November 18, 2003  
WOG-03-608

Subject: Response to Request for Additional Information – WCAP-15872-NP, Rev. 0, "Use of Alternate Decay Heat Removal in Mode 6 Refueling,"

**WCAP-15872, "Use of Alternate Decay Heat  
Removal in Mode 6 Refueling"**

**WCAP-15872-NP, R00**  
**"Use of Alternate Decay Heat Removal in Mode 6 Refueling"**  
**Request for Additional Information**  
**dated October 2, 2003**

**Figure A-3**  
**Sample Cases: Average Refueling Pool Temperature**

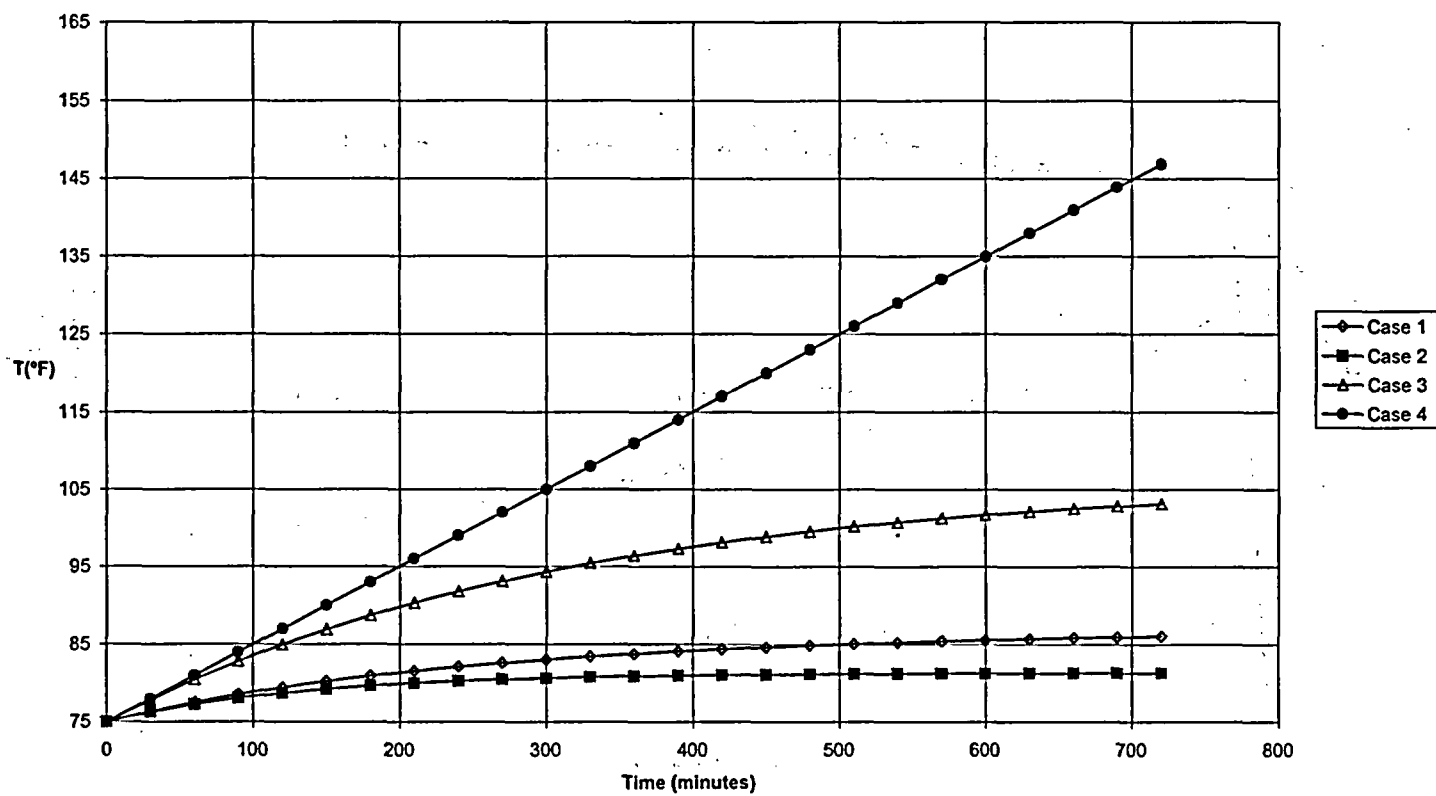
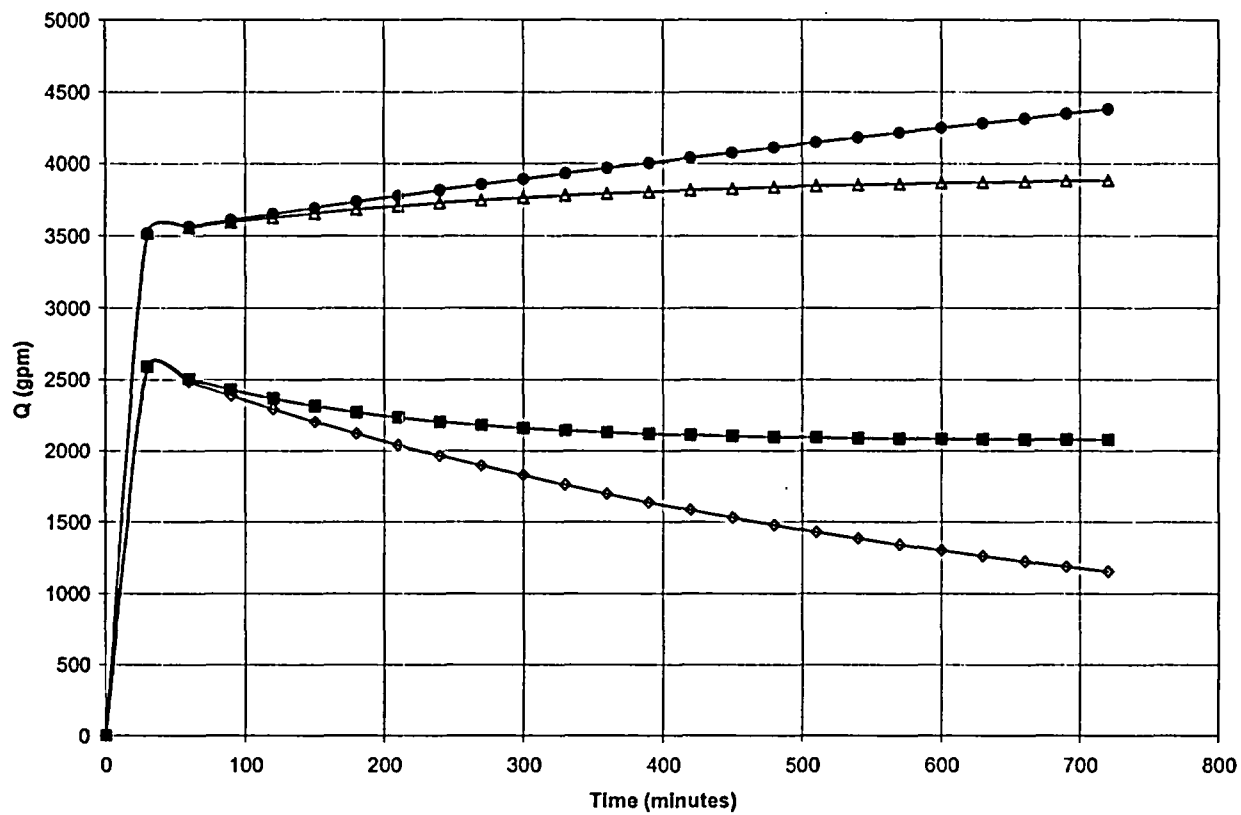
*RAI A7. Please show the derivation of the values of  $\epsilon_{mix}$  and  $\epsilon_{bypass}$  used in the results shown in Figs. A-3 and A-4 for Case 2 and Case 3.*

The mixing and bypass coefficients are defined in Appendix A and derived as shown in Appendix D. However, for the results shown in Figure A-3 and Figure A-4, these coefficients were assumed well mixed, i.e.,  $\epsilon_{mix} = 1.0$  and all alternate heat removal flow fully mixed with the natural convection flow from the core,  $\epsilon_{bypass} = 0.0$ . In Appendix A, Case 2 represents full SDC flow plus alternate cooling flow; Case 3 represents only alternate cooling flow. (Note that sample Cases 1 – 4 in Appendix A are not the same as test Cases 1 – 4 listed in Appendices B, C and D.)

**Figure B-4**  
**CCNPP Unit 2 Outage Tests: Spent Fuel Pool Flow Rate and Temperature versus Time**

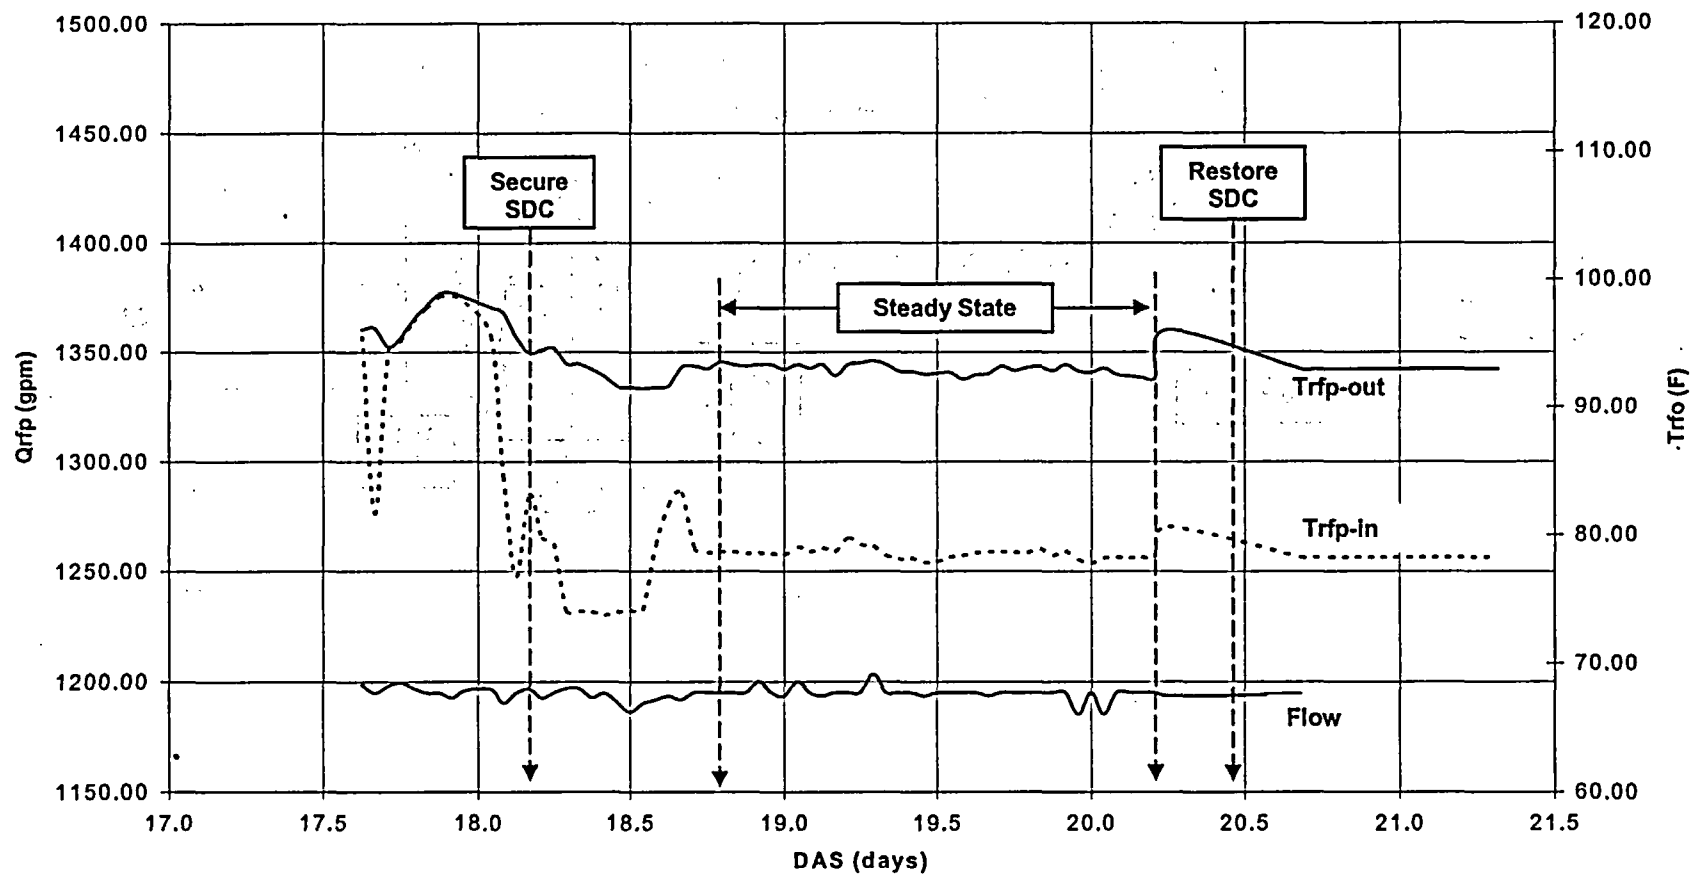
*RAI B4. Table B-2, B-3 and B-4 report time in days, hours and minutes respectively. Also, the figures use two different time scales. Please resubmit for review all tables and figures based on one time scale. (If there is a specific reason, such as clarifying a relationship, state so.)*

Time scales in Tables B-2, B-3 and B-4 are expressed in terms of clock time, total elapsed time and time in days after shutdown in order to expediently illustrate a particular result. For example, an event having a duration of minutes is not easily illustrated if expressed using a time-scale of days. Total elapsed time is used to compare measured and predicted values, while days after shutdown is the important parameter for tracking the point at which changes such as initiation and securing of shutdown cooling, head removal, initiation and securing of alternate cooling, and return to shutdown cooling occur.

**Figure D-2**  
**Flow Paths for Bypass Flow**

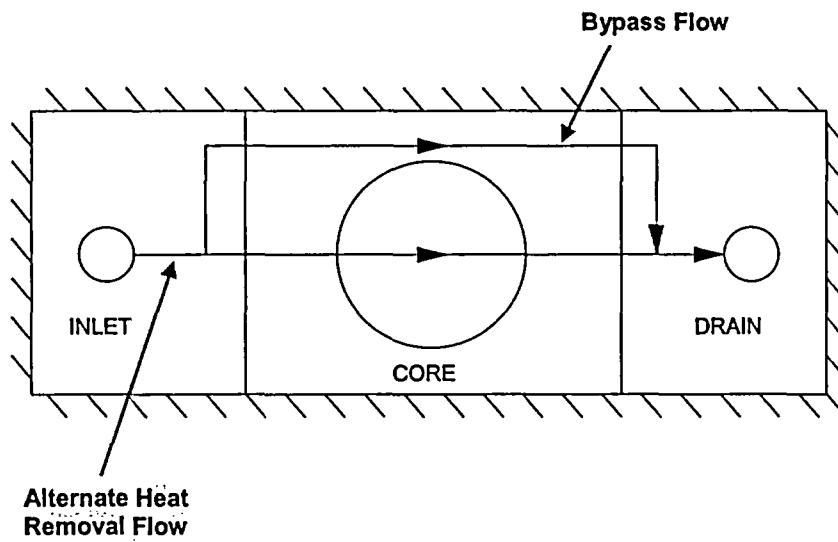
*RAI D1. Please describe the simplified one-dimensional computational model and its relation to the two-dimensional computational fluid dynamics model. How does it differ from the one-dimensional model discussed in Appendix A? When you say "computational fluid dynamics model" (without the adjective "one-dimensional") in D.3, what are you referring to - A 3D model? Figures D-3 through D-6 give 2D results. So, how are you treating the situation in Figure D-2?*

The mixing and bypass coefficients reflect three-dimensional effects into the one-dimensional analysis, shown in Appendix A, for natural circulation flow rates and refueling pool temperatures. The mixing coefficient is a measure of the uniformity of the refueling pool temperature, while the bypass coefficient, represented schematically in Figure D-2, is an indicator of the flow rate from the alternate cooling alignment that bypasses the natural circulation plume from the core.

Predictions of refueling pool temperatures using the three-dimensional CFD model, described in Appendix C, are then used to calculate both mixing and bypass coefficients. These values are then used in the one-dimensional model. Final values are selected based on agreement between the one-dimensional predictions, the CFD analysis results, and the data.
